SERVICE BULLETIN

APPLICABILITY: 2014-16MY Crosstrek Hybrid (HEV) **NUMBER:** 11-185-18
SUBJECT: DTC P0A7E: Reprogramming File Availability **DATE:** 11/27/18

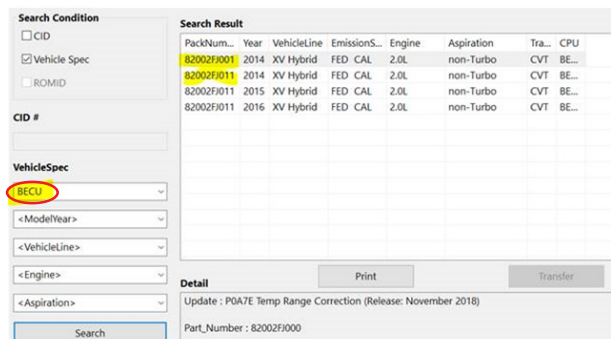
NOTE: FlashWrite currently displays the Battery Energy Control Unit as BECU when searching for available updates using Vehicle Spec as shown in the screen shot to the right.
